HEU-N. 0002 10.008 0000

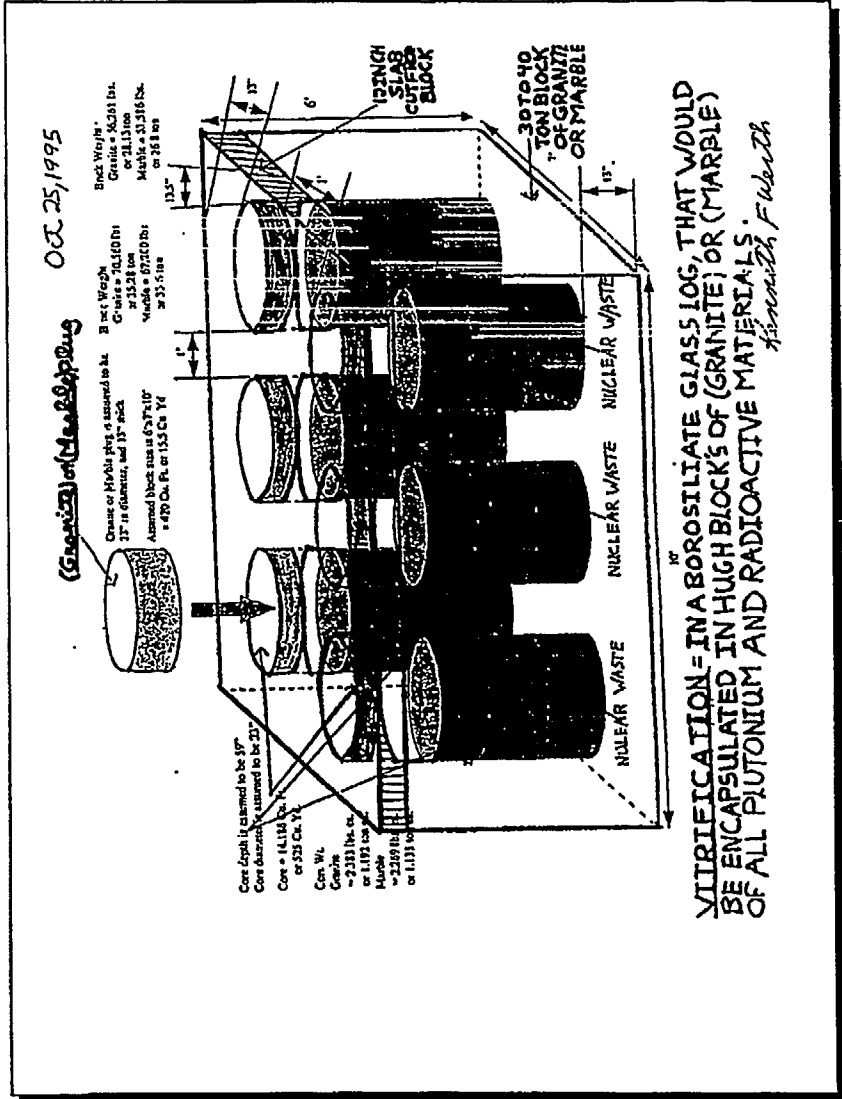
... your letter to the Nuclear Regulatory Commission, has  
just been received by me, dated OCT 25, 1975 and was  
answered by Sue E. Goggin, Public Affairs Officer, dated  
in her letter to me that the Nuclear Regulatory Commission  
is at this time regulating agency, and generally does not  
fund or initiate projects to develop or improve systems.  
NRC does fund confirmatory research, which in the high  
level waste area includes research to provide the technical  
basis needed to independently evaluate specific proposals  
being developed by the DOE for packaging and permanent  
disposal of high-level waste as stated in the letter a  
copy of my letter has been forwarded to the Nuclear Waste  
Safety and Safeguards. My own proposal and concept has  
never been reviewed by any agency, however, I do know  
that the company, but a private citizen with a fixed  
income that has taken an interest in this nuclear waste

problem at Rocky Flats and other nuclear facilities.  
If we are ever going to solve this nuclear waste problem,  
this government should take a single minded focus on  
independent geological underground burial and turn to some  
form of secure storage, but I have proposed my own concept  
that would allow both continuous monitoring and retrieval  
if it had to be. Deep geological burial does not entail waste  
management problems for future generations, but ironically  
that is not what it does precisely the reverse.  
Please review and give me your thoughts and  
comments on this proposal and concept.  
" Please Respond"  
Sincerely  
Kenneth F. Werth  
6895 Flower St  
Arvada Co. 80004  
303 7424-0790

This concept has been drawn up by me, and all questions and answers will have to come through me, for implementation.

**10.008:** The Y-12 Plant is one of the four alternative sites evaluated in the HEU EIS as having the capability to provide uranium blending processes. To be in compliance with NEPA, the HEU EIS must assess the environmental impacts of the proposed action and alternatives at all potential candidate sites without favoring one over another and provide this information to the decisionmakers.
